SERVICE-BULLETIN

Reference-N°: KTSE - SB - 2209

Self-reliant turned on Parking Lights

Step 2:

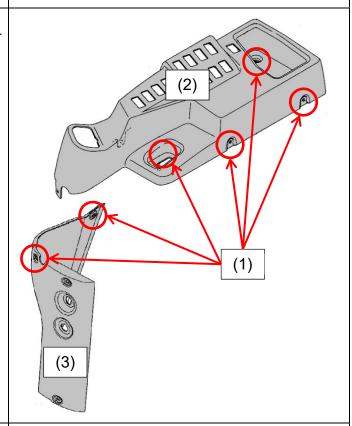
Remove the six screws (1) of the top cover (2) and the lower cover (3).
